H11697

DESCRIPTIVE REPORT

General Locality Chatham Strait

Sublocality SE of Tenakee Inlet

Figure 6 H11697 Chart Comparison (Chart 17320)

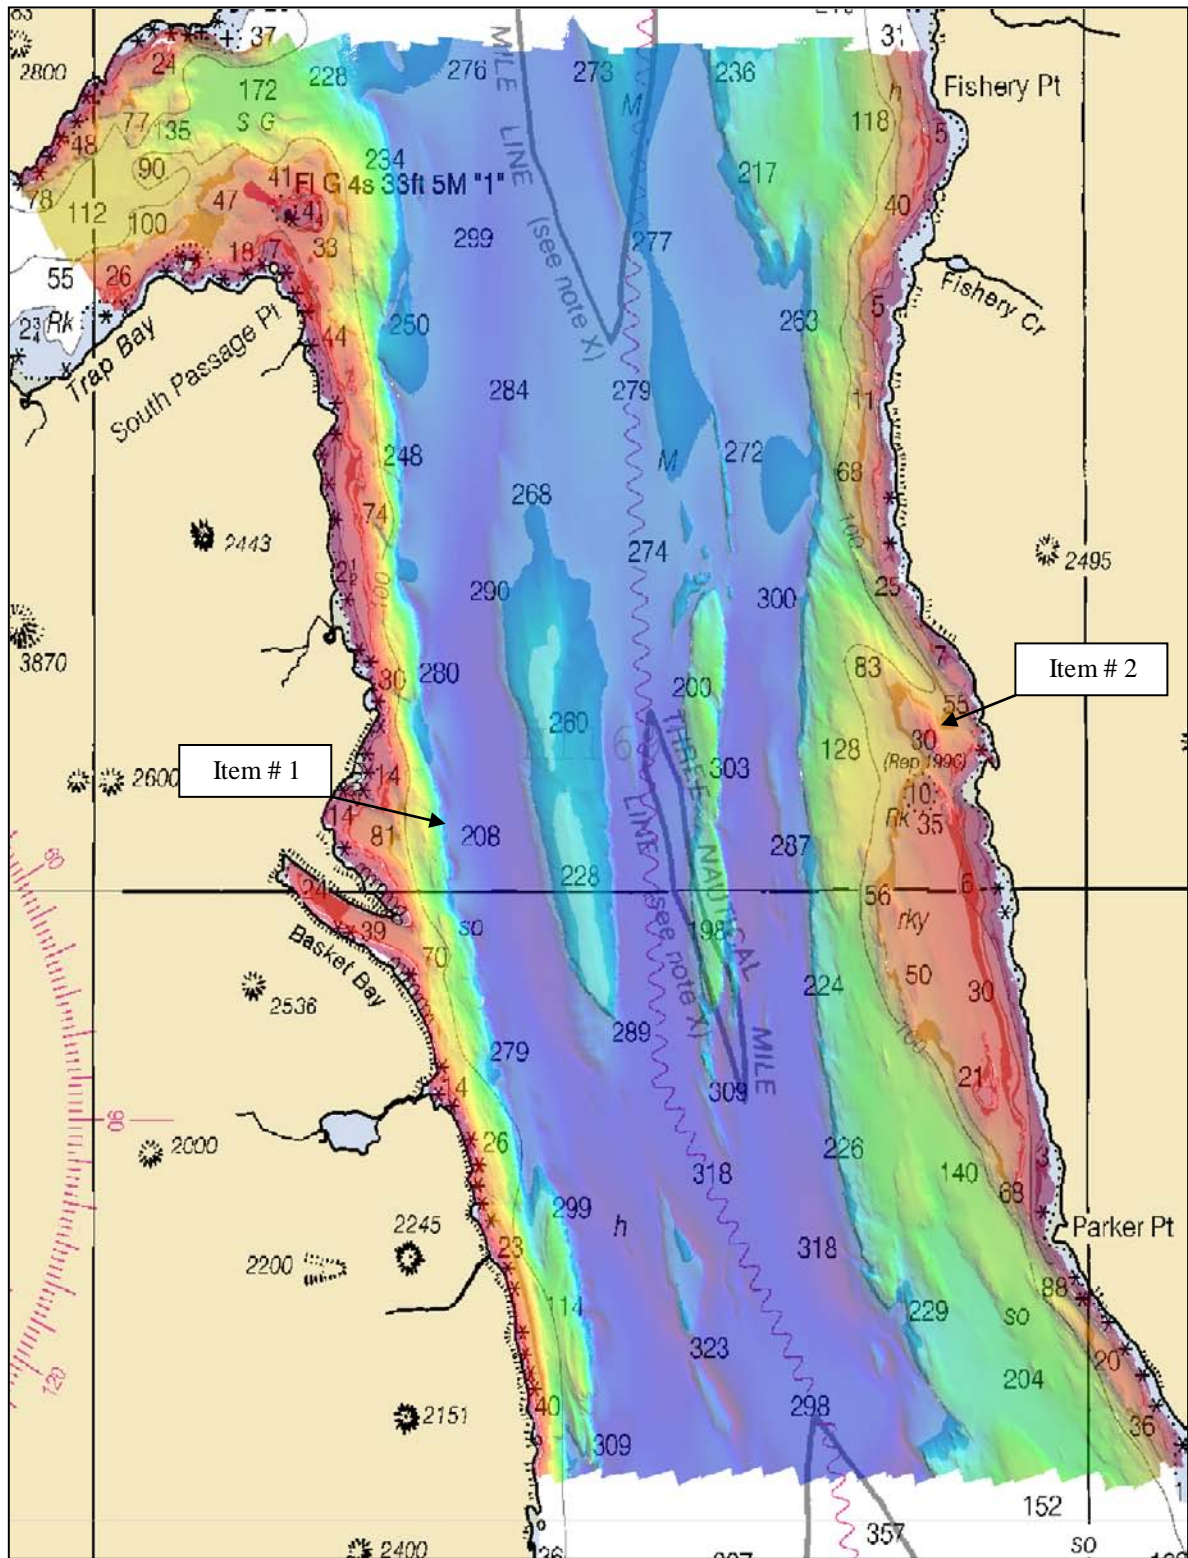
In general, the soundings from chart 17320 coincide with the soundings from H11697 to within 1 to 5 fathoms; areas that do vary to any degree are as follows:⁸

- Item # 1: Hydrographic survey H11697 revealed a depth of 306 fathoms in the vicinity of a 208 fathom sounding on chart 17320 located at 57°40'30" N, 134°52'13" W. This area was surveyed with 100% multibeam coverage.
 - Item # 2: Hydrographic survey H11697 revealed a depth of 11.3 fathoms in the vicinity of a 30 fathom sounding on chart 17320 located at 57°41'23" N, 134°43'15" W. This area was surveyed with 100% multibeam coverage. The shoaling is centered in the area depicted below.
-

⁸ Concur with clarification, several other areas showed differences greater than 5 fms, chart as shown in the HCell.

Figure 7 H11697 Electronic Chart Comparison (Chart US3AK3BM)

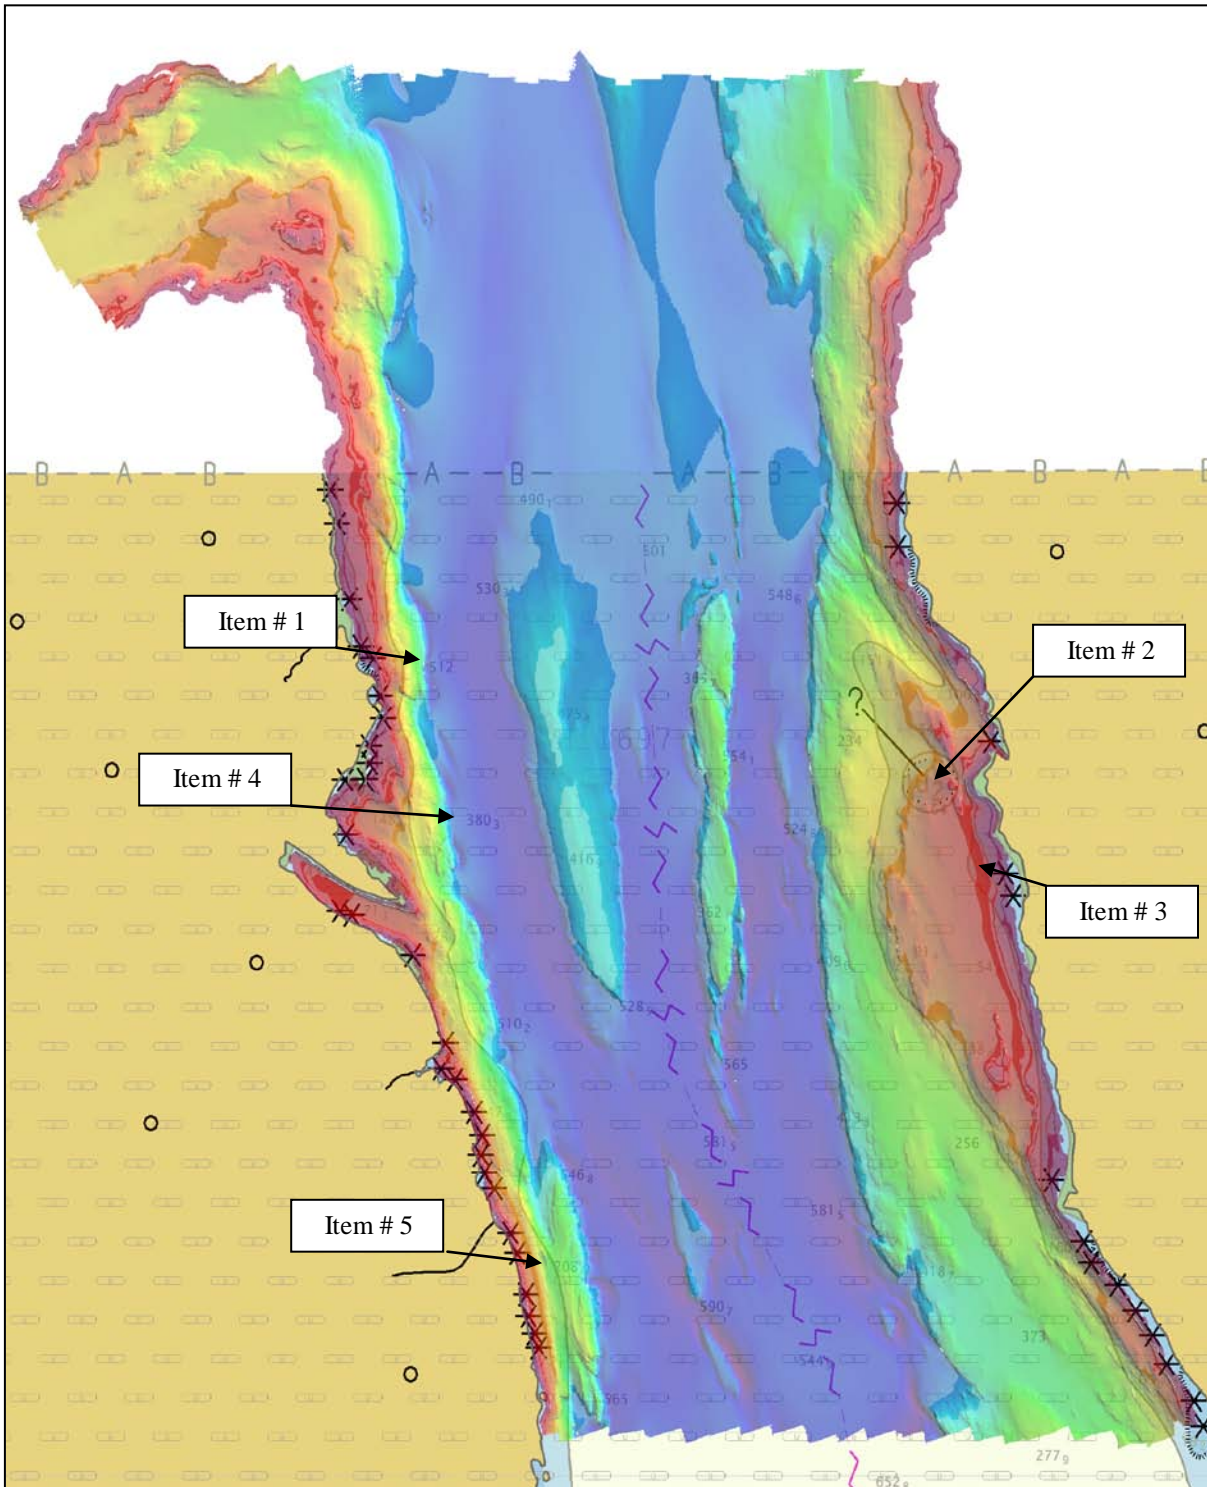
In general, the soundings from electronic chart US3AK3BM coincide with the soundings from H11697 to within 5 to 15 meters⁹; areas that do vary to any degree are as follows:

- Item # 1: Hydrographic survey H11697 revealed a depth of 555 meters in the vicinity of a 512 meter sounding on electronic chart US3AK3BM located at 57°42'03" N, 134°53'04" W. This area was surveyed with 100% multibeam coverage.¹⁰

- Item # 2: Hydrographic survey H11697 revealed a depth of 106 meters in the vicinity of a 18.2 meter sounding on electronic chart US3AK3BM located at 57°40'55" N, 134°43'20" W. This area was surveyed with 100% multibeam coverage. It should be noted that located approximately 850 meters to the NE is a 20.7 meter sounding.¹¹

- Item # 3: Hydrographic survey H11697 revealed a depth of 60 meters in the vicinity of a 10.9 meter sounding on electronic chart US3AK3BM located at 57°40'04" N, 134°42'24" W. This area was surveyed with 100% multibeam coverage. It should be noted that located approximately 400 meters to the E is a 11.7 meter sounding.¹²

- Item # 4: Hydrographic survey H11697 revealed a depth of 565 meters in the vicinity of a 380.3 meter sounding on electronic chart US3AK3BM located at 57°40'31" N, 134°52'15" W. This area was surveyed with 100% multibeam coverage.¹³

- Item # 5: Hydrographic survey H11697 revealed a depth of 340 meters in the vicinity of a 208.4 meter sounding on electronic chart US3AK3BM located at 57°36'07" N, 134°50'31" W. This area was surveyed with 100% multibeam coverage.¹⁴
-

⁹ Do not concur, 36 of the 57 charted soundings on ENC ‘US3AK3BM’ within the survey area are *not* within 5-15m of survey soundings as stated in the DR (including the 5 items in Figure 7, Endnotes 10-14 below), and 18 of these are greater than 33m different meeting the hydrographer’s criteria for itemization in Figure 7 of the DR. However all but two survey soundings are deeper than the charted sounding and the two significantly shoaler soundings are still deep enough to not be a hazard to navigation, 99m (57-43-33.85N 134-54-18.89W) and 108m (57-40-31.81N 134-54-09.66W).

¹⁰ Concur.

¹¹ Concur.

¹² Concur.

¹³ Concur.

¹⁴ Concur.
